Re: Wetland Delineation Peer Review
Request for Determination of Applicability and Associated Plan
506 Granby Road, Map 32, Parcel 52
South Hadley, MA

CONSERVATION FILING PLAN

**506 Granby Road
 South Hadley, MA
 Map 32 Parcel 52**

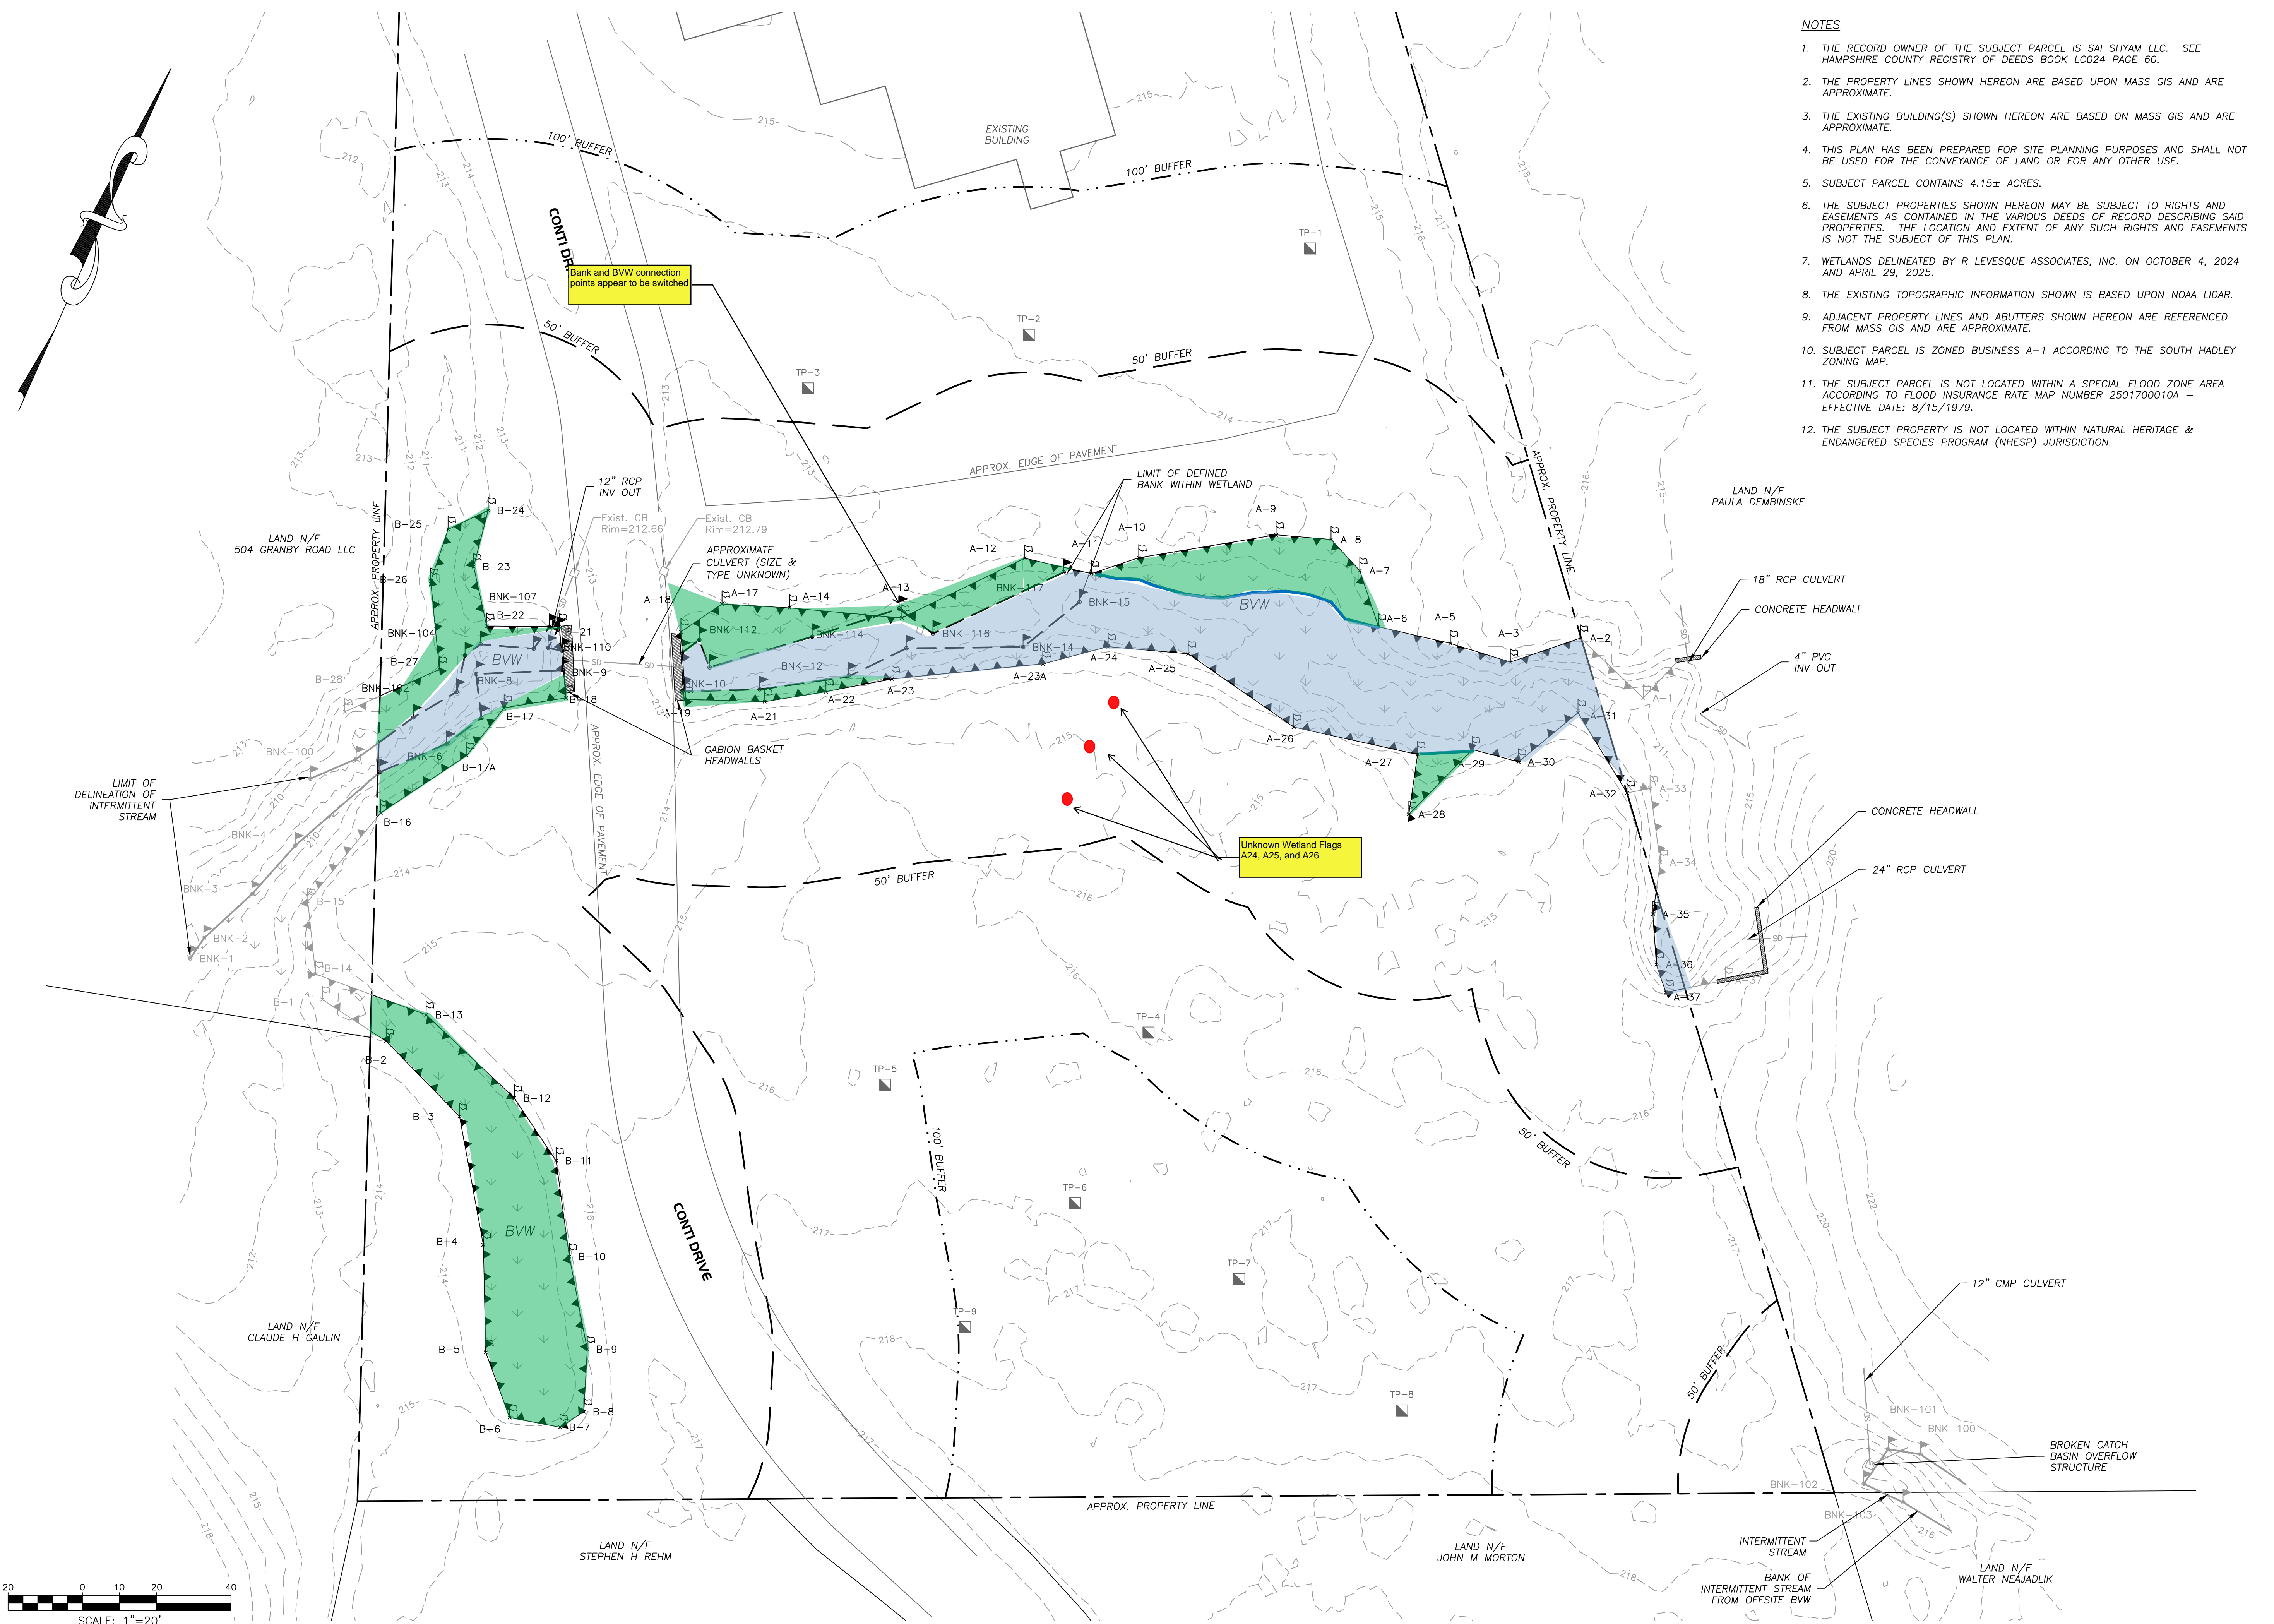
The main east-west area identified on the plans as BVW resource area clearly contained flow on the day of the site review and a defined bank. Based upon a review of the USGS Quadrangle Map for the site and USGS Streamstats, the stream does not qualify as perennial per 310 CMR 10.58(2). The stream appears to have been over widened in the past, possibly at the time when offsite stormwater connections were last installed. GZA observed a wide and relatively flat bottom stream that was deeply incised within a relatively steep bank. The bank confined the stream and was bordered in areas by fringe and pocket bordering vegetated wetlands. Due to the discrepancy of GZA’s resource area finding, we are providing a flag review **Table 2** below and have annotated the RDA plan.

Flag ID	RLA Resource	GZA Resource	Notes	Flag ID	RLA Resource	GZA Resource	Notes
A-2	BVW	Bank		B-2	BVW	BVW	
A-3	BVW	Bank		B-3	BVW	BVW	
A-4	BVW	Bank		B-4	BVW	BVW	
A-5	BVW	Bank		B-5	BVW	BVW	
A-6	BVW	Bank		B-6	BVW	BVW	
A-7	BVW	BVW	No Bank flag	B-7	BVW	BVW	
A-8	BVW	BVW	No Bank flag	B-8	BVW	BVW	
A-9	BVW	BVW	No Bank flag	B-9	BVW	BVW	
A-10	BVW	BVW	Bank resumes	B-10	BVW	BVW	
A-11	BVW	BVW		B-11	BVW	BVW	
A-12	BVW	BVW		B-12	BVW	BVW	
A-13	BVW	BVW	Fix connection on plan	B-13	BVW	BVW	
A-14	BVW	BVW		B-16	BVW	BVW	
A-15	BVW	BVW		B-17	BVW	BVW	On ground, needs stake
A-16	BVW	BVW		B-17A	BVW	BVW	
A-17	BVW	BVW		B-18	BVW	BVW	
A-18	BVW	BVW		B-21	BVW	BVW	
A-19	BVW	BVW		B-22	BVW	BVW	
A-20	BVW	BVW		B-23	BVW	BVW	
A-21	BVW	BVW		B-24	BVW	BVW	
A-22	BVW	BVW		B-25	BVW	BVW	
A-23	BVW	Bank		B-26	BVW	BVW	
A-23A	BVW	Bank	This flag was high on the bank	B-27	BVW	BVW	Shift 3’ upgradient to make bend
A-24	BVW	Bank		B-28	BVW	BVW	
A-25	BVW	Bank					
A-26	BVW	Bank

A-27	BVW	Bank	Connects to A-29 as Bank				
A-28	BVW	BVW					
A-29	BVW	Bank	Connects to A-27 as Bank				
A-30	BVW	BVW					
A-31	BVW	Bank

Flag ID	RLA Resource	GZA Resource	Notes	Flag ID	RLA Resource	GZA Resource	Notes
A-32	BVW		Flag was found on ground and not confirmed				
A-35	BVW	Bank					
A-36	BVW	Bank					
A-37	BVW	Bank

Flag ID	RLA Resource	GZA Resource	Notes	Flag ID	RLA Resource	GZA Resource	Notes
BNK-5	Bank	Bank		BNK-102	Bank	Bank	
BNK-6	Bank	Bank		BNK-103	Bank	BVW	Move up gradient 4'
BNK-7	Bank	Bank	Connect to BNK-9	BNK-104	Bank	Bank	
BNK-8	Bank	Remove		BNK-105	Bank	Bank	Connect to B107
BNK-9	Bank	Bank	Connect to BNK-7	BNK-106	Bank	BVW	Remove flag
BNK-10	Bank	Bank	Culvert Point	BNK-107	Bank	Bank	Fix label on plan
BNK-11	Bank	Bank		BNK-108	Bank	Bank	
BNK-12	Bank	Bank		BNK-109	Bank		Remove flag
BNK-13	Bank	BVW	Move upgradient toward A-22	BNK-110	Bank		Extend out to SW culvert (5')
BNK-14	Bank	Bank		BNK-111	Bank	Bank	Ends at headwall
BNK-15	Bank	BVW	Move upgradient toward A-23A	BNK-112	Bank	Bank	
				BNK-113	Bank	Bank	
				BNK-114	Bank	Bank	
				BNK-115	Bank	Bank	Fix connection on plan
				BNK-116	Bank	Bank	
				BNK-117	Bank	Bank

The Commission may wish to have the RDA Site Plan and narrative updated to reflect the changes to wetland resource area name and configuration observed by GZA.

The Commission may wish to inquire about the three wetland flags located within the forested interior of the property that were not identified on the Site Plan.

The Site contains Local, State, and Federally regulated wetlands. The State regulated resources are generally flagged accurately in the field despite our opinion about the resource area types. Small adjustments to the flag locations are described in **Table 2** and on the attached annotated Site Plan. Based on our field observations, we recommend that the Commission request the Applicant to add the off-site BVW area to the north of the building. The map should be updated based on the Commission's and Applicant's discussion of the peer review comments. The Commission may wish to discuss a culvert maintenance plan at this location due to what appears to be a frequent blockage issue.
